**WHITE LAKE TOWNSHIP
INTER-OFFICE MEMORANDUM**

**SUBJECT: Lakepointe
Final Site Plan Re-approval
Revised Planned Development Agreement Approval**
Located on the northeast corner of Union Lake Road and Carpathian, consisting of approximately 13.32 acres. The property is currently zoned PD (Planned Development). Identified as parcel number 12-36-177-008.

RE: Lake Pointe – Final Site Plan and Final Engineering Plan –7th Review

**RE: Lake Pointe – Final Site Plan Backcheck #4
Parcel Number 12-36-177-003**

6 BUILDINGS I - REAR ELEVATION
 A203 SINGLE STORY TYPE "B" - UNITS (29-32)

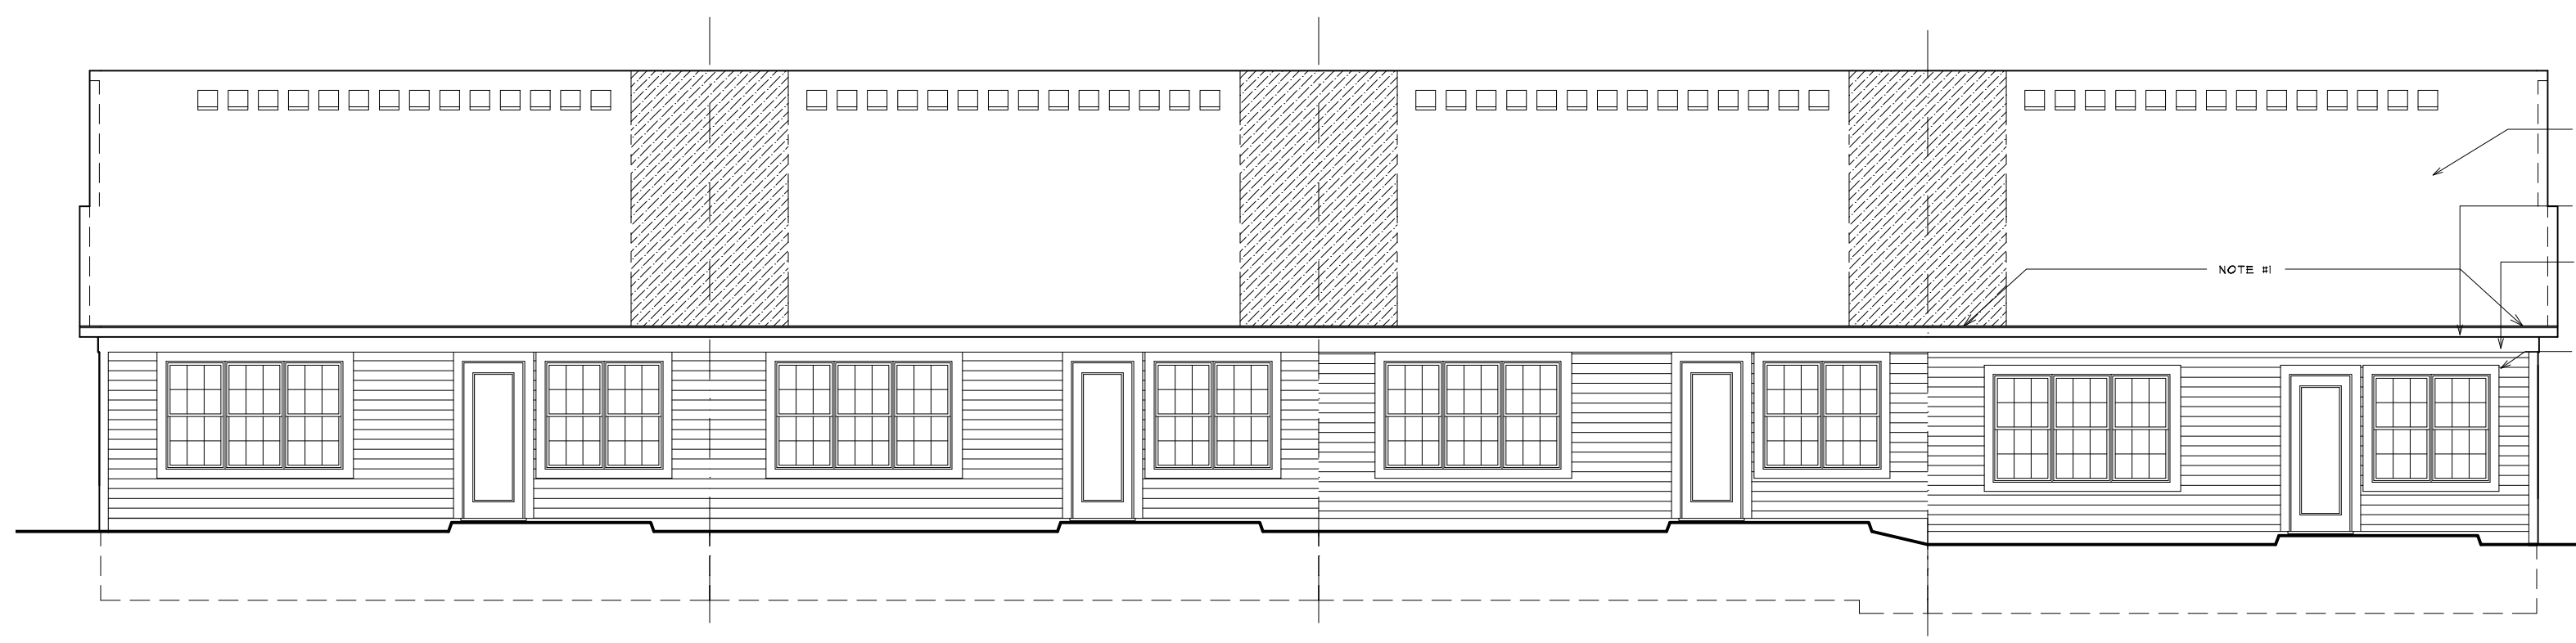
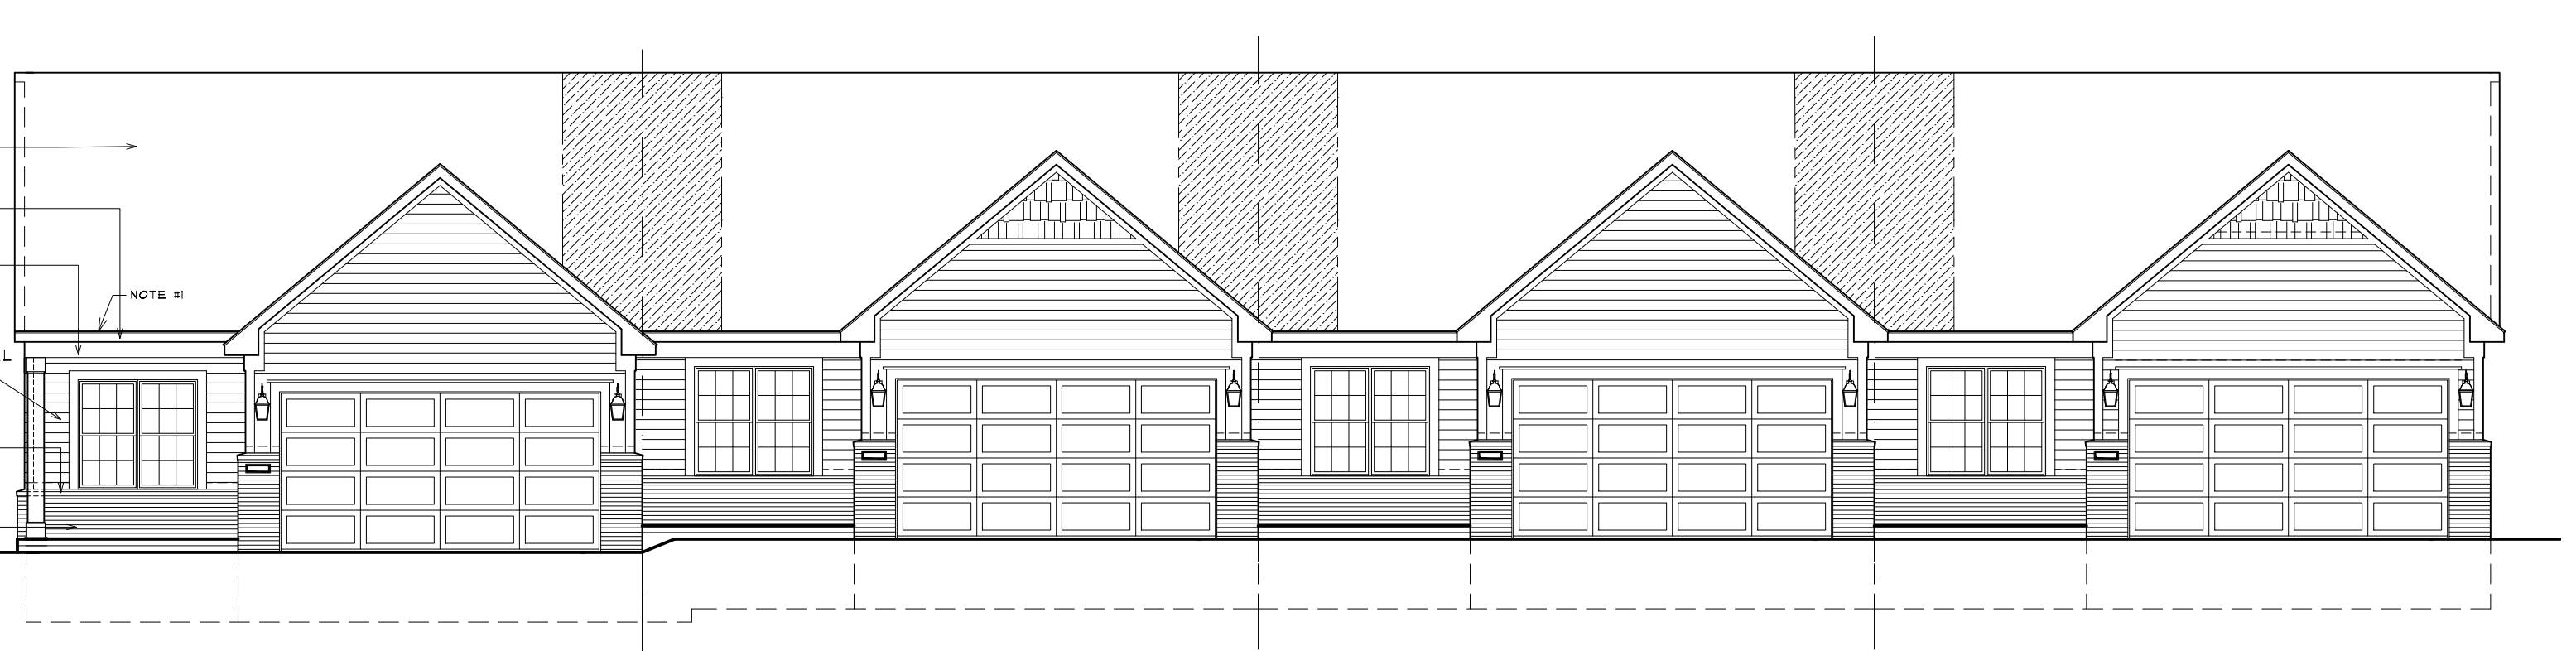
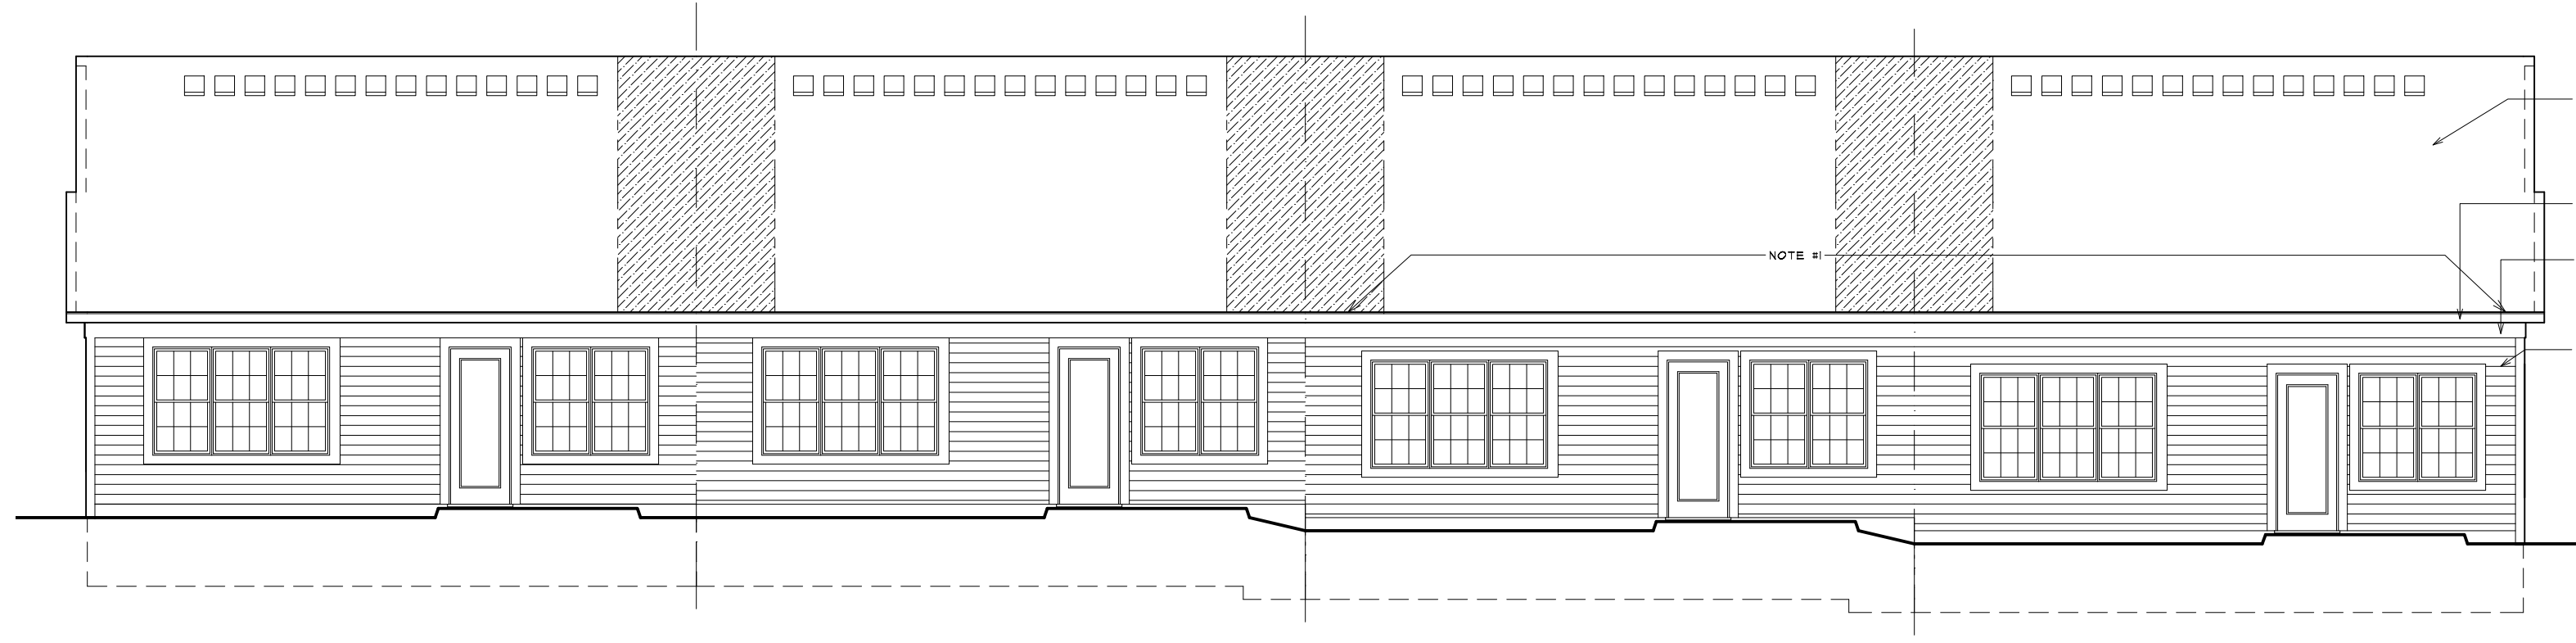
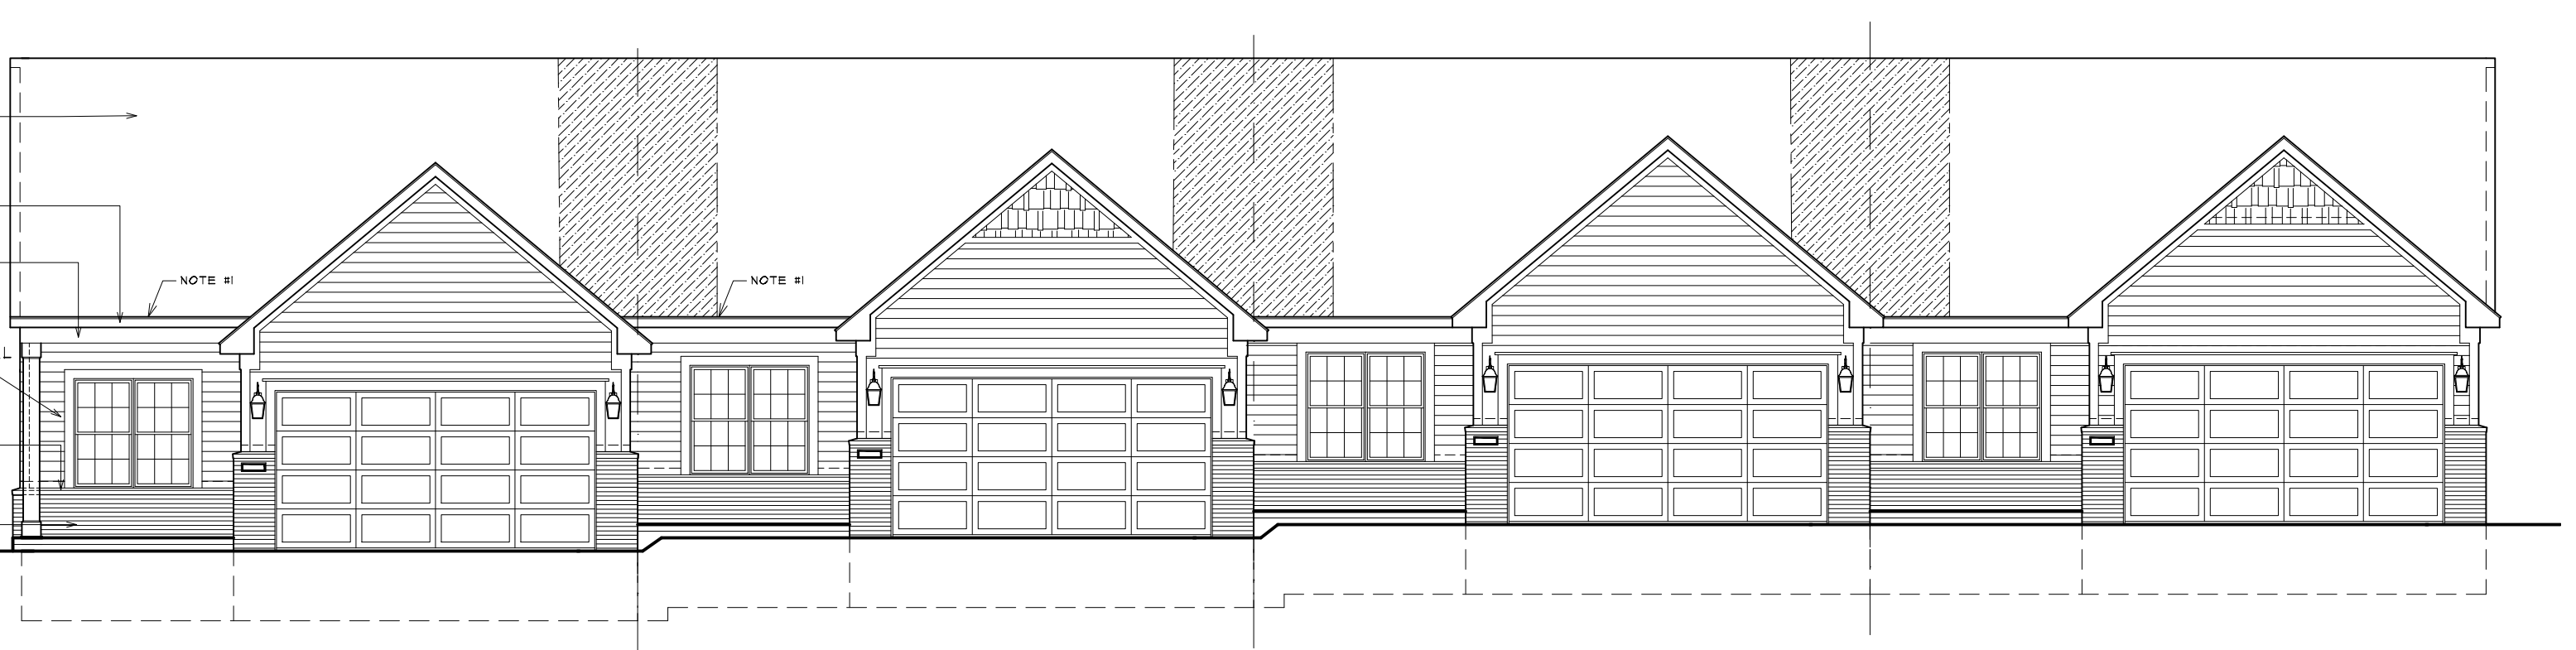
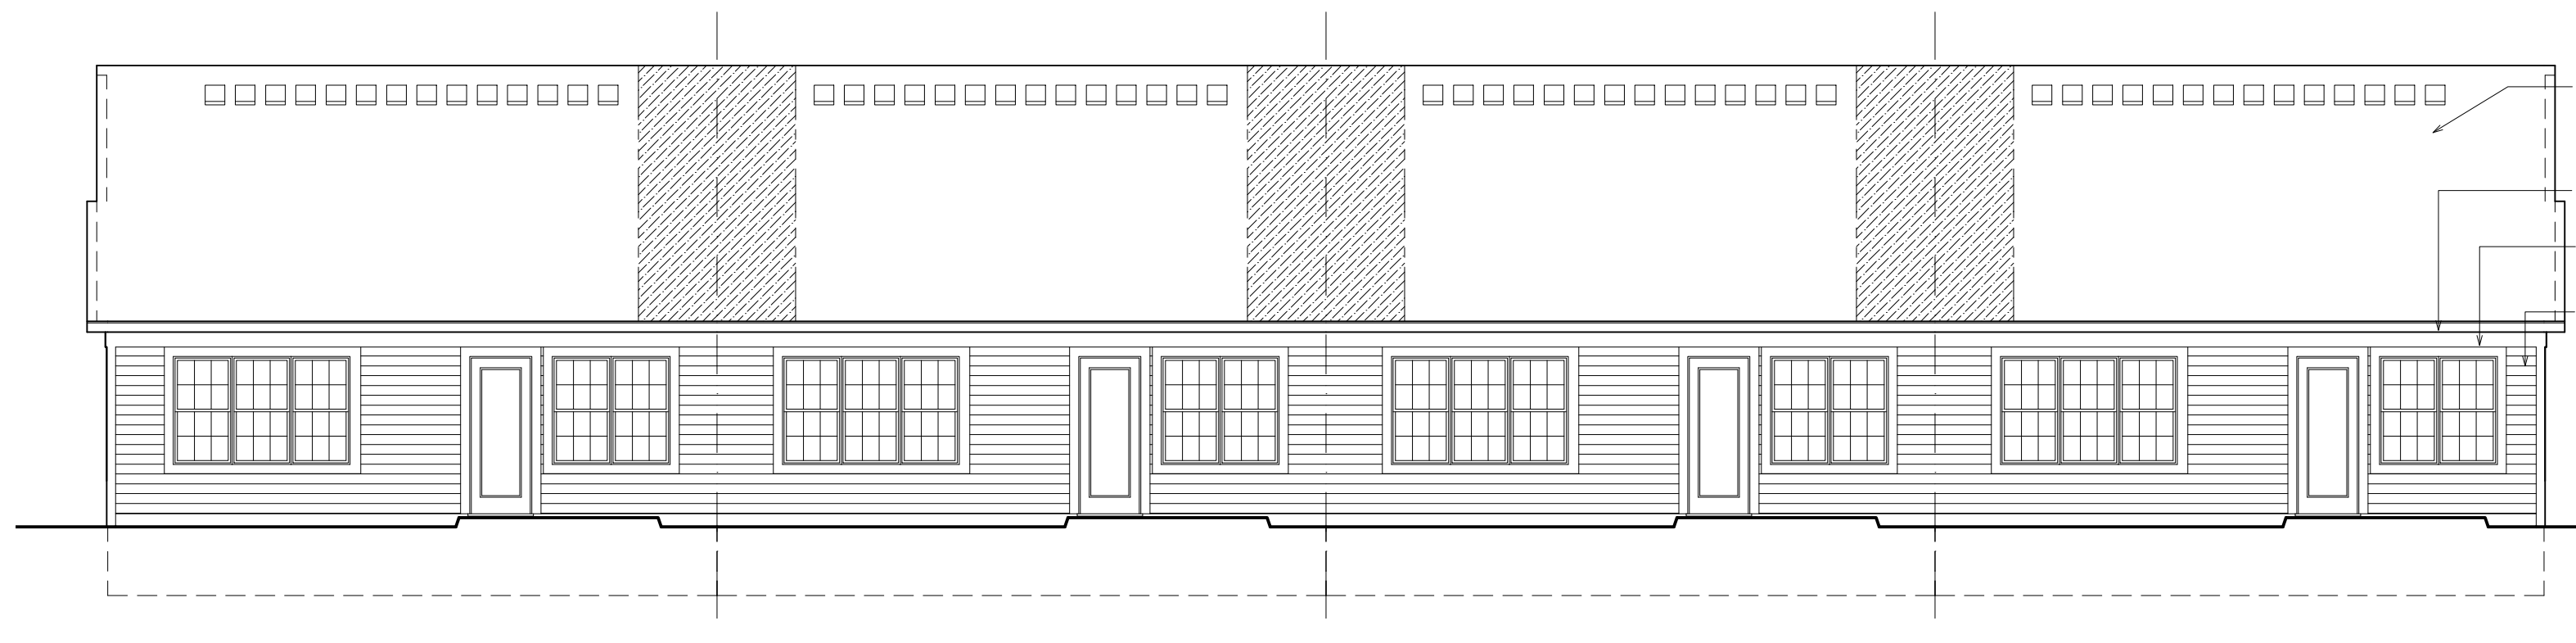
- As stated in previous correspondence (dated February 22, 2021), **the building materials shall be labeled on the building elevations, Sheets A201 and A203.** (Comment outstanding). (Comment remains outstanding). (Comment addressed. Material notations have been added to the elevations).
